ASB-1023

## Service Bulletin

**Subject:** TM-732A S-Meter Squelch Scan Stop Improvement **Date:** May 26, 1993

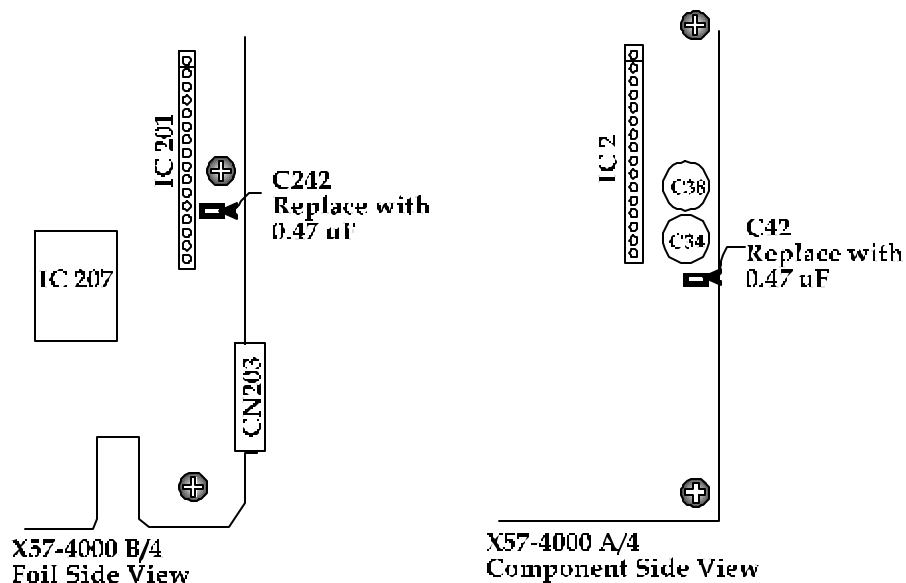
On some early versions of the TM-732A scan will not stop when operating in the S-Meter Squelch mode, even when the transceiver receives a signal with the same level as specified when initiating the S-Meter squelch mode.

Change the value of C42 in the 144 MHz TX/RX Unit (X57-4000 A/4) and C242 in the 430 MHz TX/RX Unit (X57-4000 B/4) from 1 uF to 0.47 uF.
